Subject: **Docket No. 50-206, 50-361, 50-362, and 72-041
Response to Request for Additional Information and Supplement
Regarding Permanently Defueled Emergency Plan
Amendment Application Numbers 223, 267, and 252
San Onofre Nuclear Generating Station, Units 1, 2, and 3 and ISFSI**

ENCLOSURE 1

Response to NRC Request for Additional Information (RAI)

Regarding Permanently Defueled Emergency Plan

Figure B-1: Emergency Response Organization

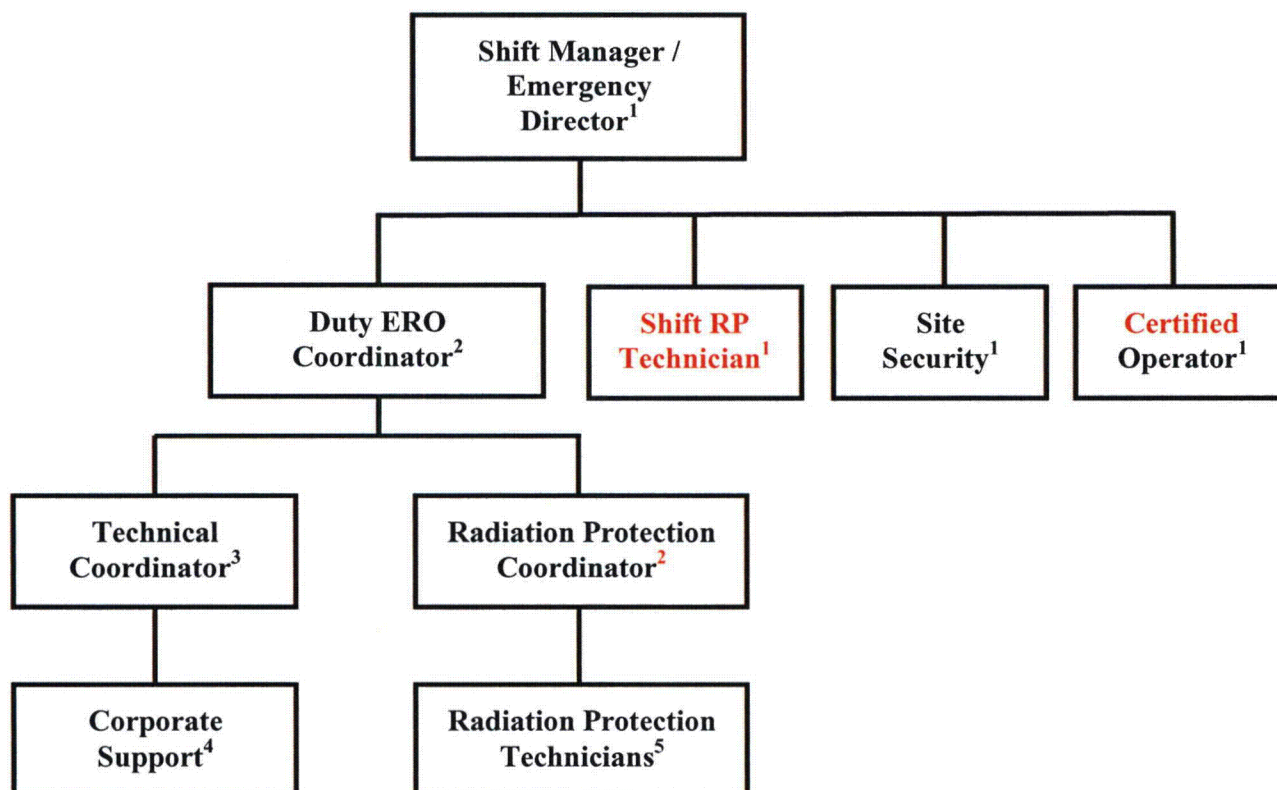
Note (1) under Figure B-1, "Emergency Response Organization," states, "Shaded boxes indicate shift positions." There are no shaded boxes on this figure. Please revise as required to clarify or provide basis for note.

In addition, Note 2 identifies that the augmented positions are identified by "shadowed boxes." This Note will also be revised to not reference shadowing and the shadowing will be removed from the associated boxes in the Figure.

Note (4) under Figure B-1 states, "Southern California Edison will provide or arrange for additional technical, maintenance and other support as needed to restore station to pre-event condition." Please describe what arrangements are or will be in place to expedite support for these functions. In addition, in what timeframe would outside sources be expected to be available to perform these function(s)?

Note (5) under Figure B-1 states, "They may be provided by an Emergency Services Contract." Will these personnel be initially trained and maintain training qualifications as provided in Section O? In addition, in what timeframe would outside sources be expected to be available to perform radiation protection function(s)?

Note: The shading and shadowing effects and Notes 1 and 2 are being revised as identified in the response to SONGS-RAI-09. Those changes are also shown in the below figure.

1. On-shift positions.
2. Augmented position that will respond within 2 hours when called.
3. Pre-Designated supplemental position, called as needed based on event.
4. Southern California Edison will provide or arrange for additional technical, maintenance and other support as needed to restore station to pre-event condition.
5. Additional Radiation Protection Technicians are called to support response as needed. They may be provided by an Emergency Services Contract. Shift personnel are trained as radiation workers and to perform limited RP duties until additional support is available.

The boxes whose titles are annotated with Note 1 are the boxes that are supposed to be "shaded." However, the phrase "Shaded boxes indicate" is redundant, since the correct titles in the boxes are annotated with Note (1) (in superscript). Therefore, Note 1 will be revised to not reference shading and simply state "On-shift positions." Note 1 will be referenced in the Figure for the four on-shift positions (three that were included in the originally submitted PDEP and the fourth added by the SCE response to SONGS-RAI-06) by a superscript 1 after each position, and no shading will be used for the associated boxes.

The SONGS PDEP Figure B-1 is revised to delete the shading and shadowing effects and Notes 1 and 2 are revised as follows:
